Spanish ADVISORY NOTE

Proposed
Spanish Advisory Note Number: ES01R001

Subject: Requirement regarding DC current and loop resistance

Figure A.3.1: TE voltage/current characteristics

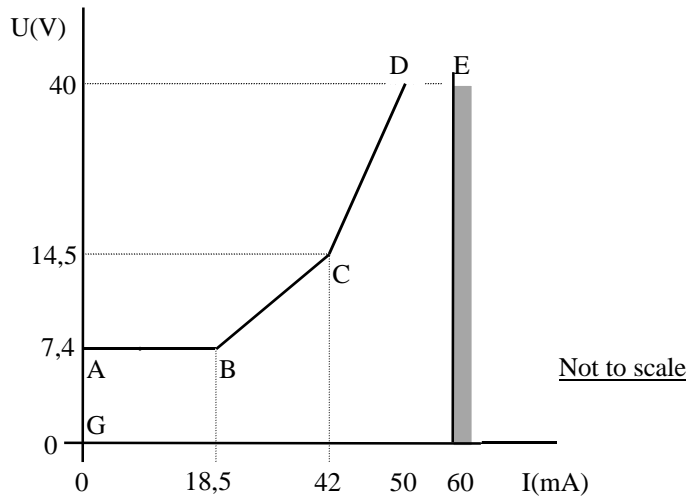
Requirement: The DC voltage/current characteristics of the TE within the operating range as stated in subclause 4.7 shall not exceed the limits given in table A.3.1 and shown in figure A.3.1.

Point	Voltage (V)	Current (mA)
A	7,4	0
B	7,4	18,5
C	14,5	42
D	40,0	50,0
E	40,0	60,0
F	0	60,0
G	0	0

Note: Limits for intermediate currents can be found by drawing a straight line between the break points on a linear voltage/current scale.

Figure A.3.2:

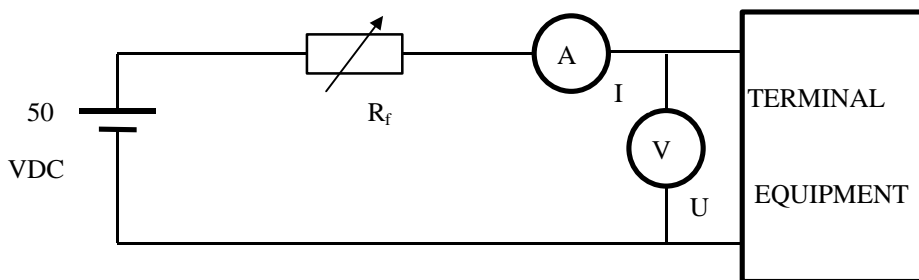
Feed voltage 50V. Feed resistance: each of the following: 230 W, 850 W, 2050 W and 3200 W. Polarity shall be switched between each feed resistance

In sequence, select a feed resistance value according to the DC feeding arrangement and then cause the TE to enter the loop state after making sure that the TE has been held at least 1 minute in quiescent state. When the terminal has been in the loop state for at least
1,2 s, measure the DC current drawn by the TE and the DC voltage across the TE for each of the feed conditions. Allow sufficient setting time, to a maximum of 3 s, to ensure that the measured value is satable to within +/_0,5% for at least 0,2 s. Then repeat the sequence for other measurement points, repeating each time a transition from quiescent state to loop state.
